STANDARD-TRIUMPH MOTOR COMPANY, INC.
WESTERN ZONE

TO: ALL TRIUMPH DEALERS - WESTERN ZONE

DEPT: SERVICE AND PARTS

SUBJECT: SPITFIRE WATER SHIELDS

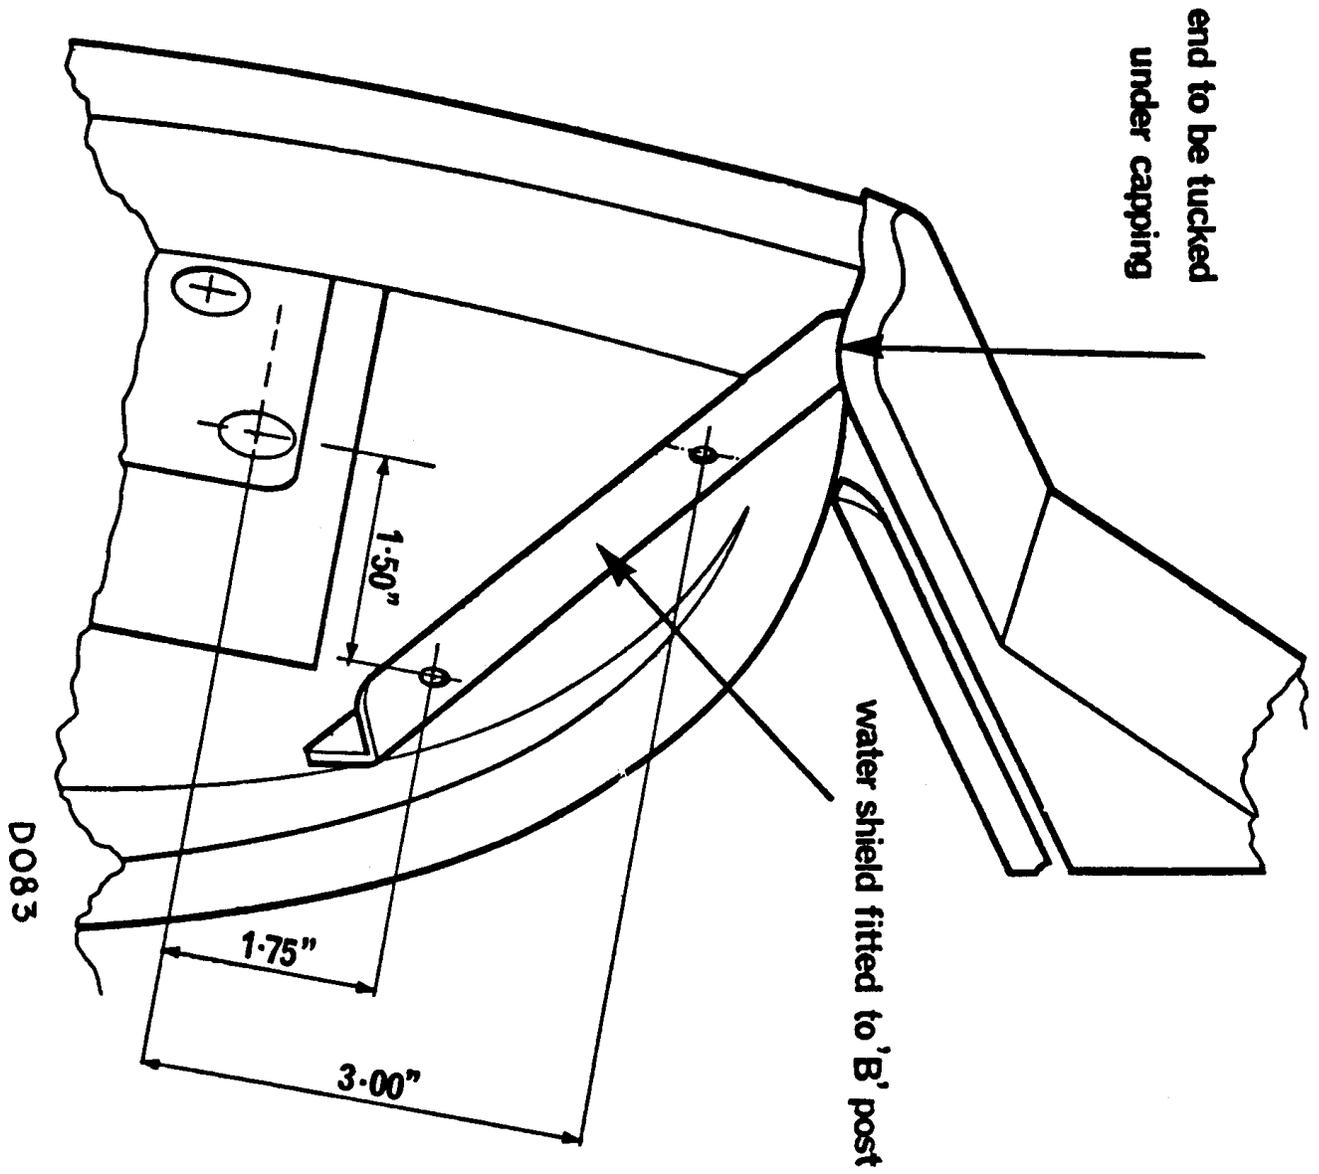
To eliminate possible water entry into the body, rubber shields have recently been fitted to the forward face of the "B" posts on Spitfire models.

These shields, part numbers 569241 L.H. and 569242 R.H. are pop-riveted in position with 1/8" dia. Imex rivets AD46, as shown in the illustration.

All cars in service prior to the introduction of this scheme should be modified to the above condition.

BULLETIN T-63-25

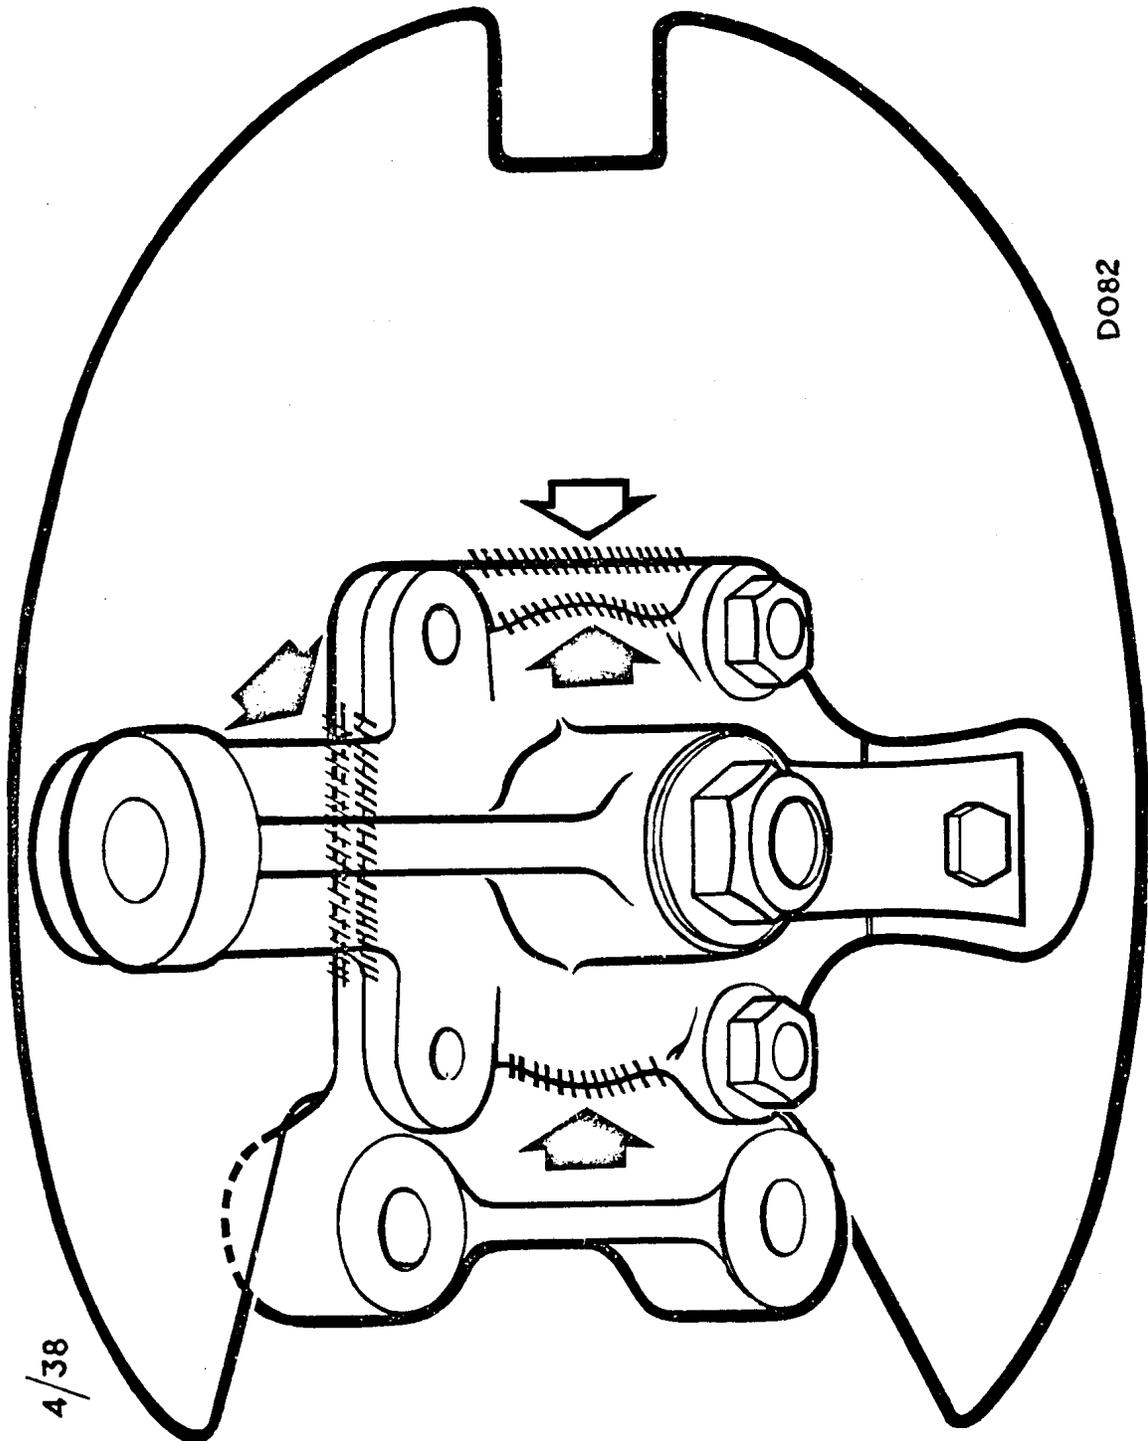
Water may enter the front hubs between the dust shield and caliper mounting bracket and damage the hub inner bearing on Spitfire and Sports Six models equipped with disc brakes. The hub outer bearing is seldom affected.

1. The sealing operation was introduced in production at (approx.)
Commission Numbers HB-6800 -FC-1675

2. Built-up units, withdrawn from Spares stocks, must be sealed in
accordance with the above instructions, before being assembled to
vehicles.

The exact incorporation Commission Numbers referred in Page 1 of this
Bulletin have been confirmed as FC-1936 Spitfire and HB-6835 Sports Six
and therefore, no action will be necessary after these numbers.

Future production from FC-2393 and HB-7082 will incorporate a rubber seal
between the dust shield and caliper mounting bracket. This modification
cannot be applied to prior commission numbers.

Diaphragm Assembly

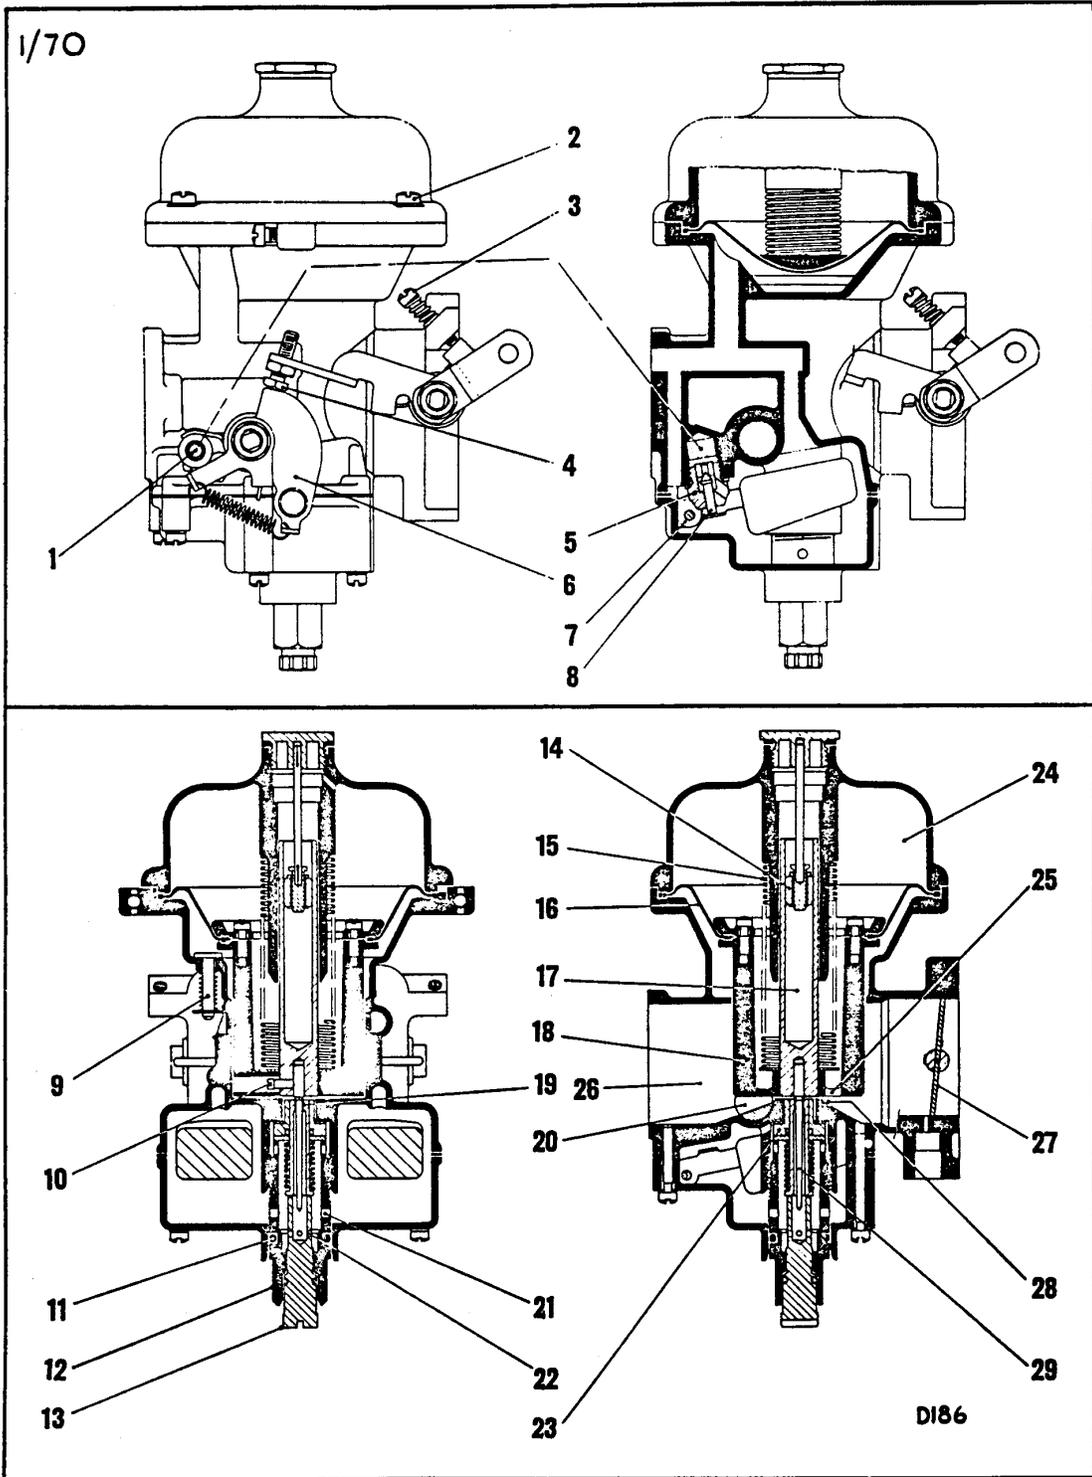
A bead and locating tab is moulded to both the inner and outer radii of the diaphragm to ensure correct location. The diaphragm is secured to the air valve by a ring and screws with lockwashers and it is essential that the bead is correctly positioned and the screws are tight.

Location for the bead and tab on the outer radii of the diaphragm is provided by a channel at the top of the main body.

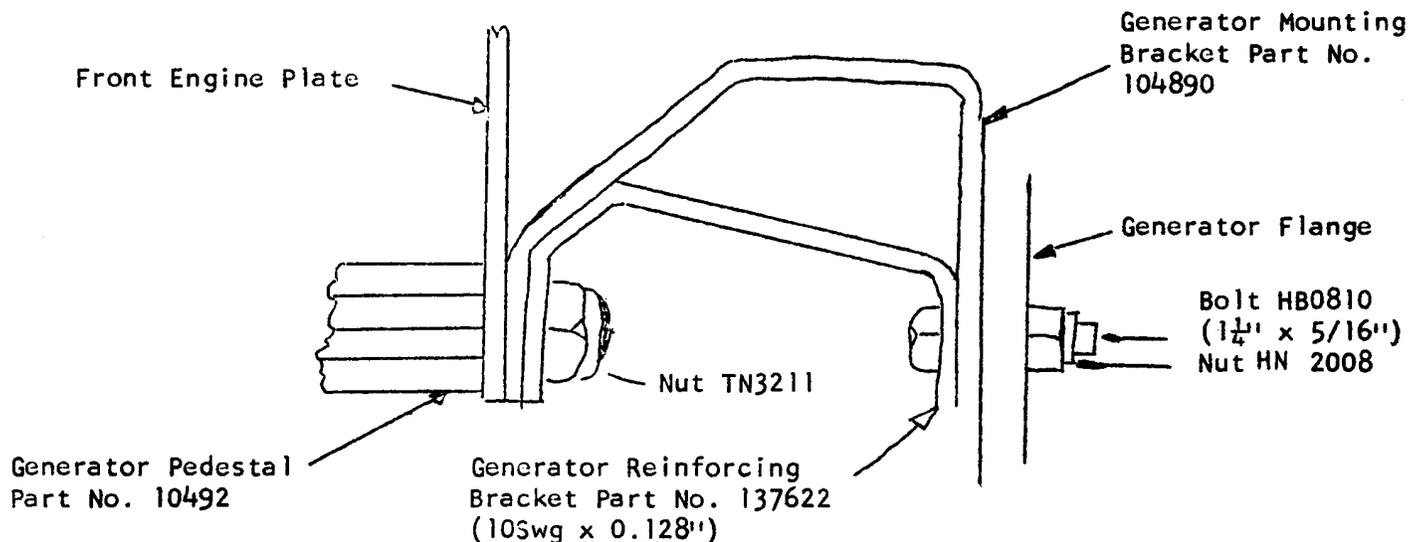
Generator mounting bracket	104890	1 off
Generator reinforcing bracket	137622	1 off
Generator bolt	HB0810	1 off
Generator bolt nut	HN2008	1 off

The diagram shown below illustrates the location of the additional reinforcing bracket.

The reinforced bracket was introduced on production at the following engine numbers: GA-117163-E, GC-9042-E and FC-12035-E.

Washer
Part No. 513382

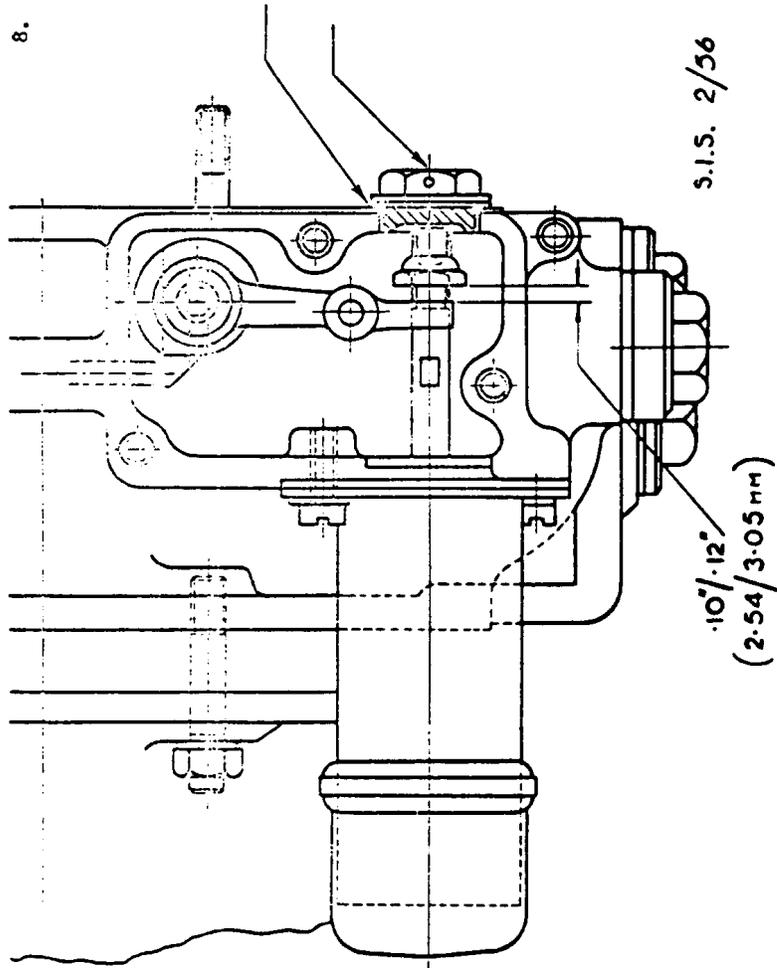
2. Remove faulty solenoid.
3. Remove the existing hexagon headed plug and replace it with the new recessed plug. This will reduce the excessive free movement of the solenoid plunger.
4. Insert a 3/16" (4.76 mm) diameter peg or drill shank through the valve operating lever locating the lever with the hole in the casing.
5. Energize the solenoid.
6. Adjust the solenoid shaft nut until its face is flush with the operating lever.
7. Remove the peg or drill and switch off the solenoid.
8. Reoperate the solenoid and make sure that the hole in the lever lines up with the hole in the case.
9. Check with the ammeter connected between the solenoid and main feed wire to ensure that the solenoid points open when operated. The current should read approximately 2 amps.

8. Insert $3/16$ " dia. peg or drill shank through valve operating lever locating the lever with hole in casing. With solenoid rod pushed hard against back stop check distance between solenoid rod nut face and operating lever face. Adjust to 0.10 "/ 0.12 " by use of various thickness washers between housing and backstop.
